Access Compliance Report

Public Rights-of-Way

(Curb Ramps)

Intersection ID: 10026804	Main Street: FOREST_POINT_CR	Cross Street: N/A	Location: SW
ADA ID: 5D7427801DCB	Ramp Type: PerpDiag	Initial Pass/Fail: Fail	Overall Compliance: No
Severity Score: 21.25			
Codes/Mitigation Info/Possible Solution		Field Measurements/Component Compliance

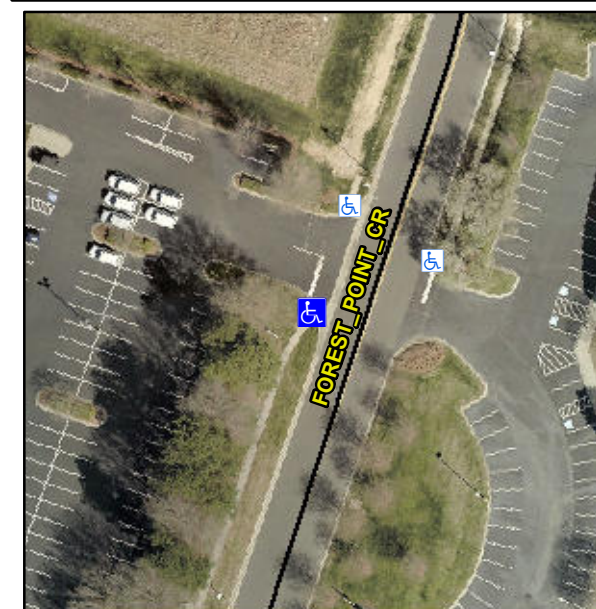
Not Found, R304.5.1, R304.2.2

Compliance	Description	Data	Compliance	Description	Data
N/A	Ramp Length (in)	60.0	No	Ramp Slope (%)	10.0
No	Ramp Width (in)	39.0	Yes	Ramp XSlope (%)	1.4
N/A	Flare Type LT	N/A	N/A	Flare Type RT	N/A
N/A	Flare Slope LT (%)	N/A	N/A	Flare Slope RT (%)	N/A
N/A	Flare Traversable LT?	N/A	N/A	Flare Traversable RT?	N/A
N/A	Landing Length (in)	N/A	N/A	DWS Provided?	N/A
N/A	Landing Width (in)	N/A	N/A	DWS Contrast?	N/A
N/A	Landing Slope (%)	N/A	N/A	DWS Length (in)	N/A
N/A	Landing X Slope (%)	N/A	N/A	DWS Full Width?	N/A
N/A	Landing Curb? (Y/N)	N/A	N/A	DWS Offset (in)	N/A
N/A	Shared Landing?	N/A			
N/A	Gutter Ponding?	N/A	N/A	Gutter Slope (%)	N/A
N/A	Gutter Lip Ht (in)	N/A	N/A	Gutter X Slope (%)	N/A
N/A	Painted X Walk1?	No	N/A	Painted X Walk2?	No
	X Walk 1 Direction	To NE		X Walk 2 Direction	To SE
N/A	X Walk 1 Width (in)	N/A	N/A	X Walk 2 Width (in)	N/A
	X Walk 1 Slope (%)	3.4		X Walk 2 Slope (%)	2.3
	X Walk 1 X Slope (%)	2.8		X Walk 2 X Slope (%)	0.9

Remove & Replace Curb Ramp With Two New Directional Ramps or Equivalent.
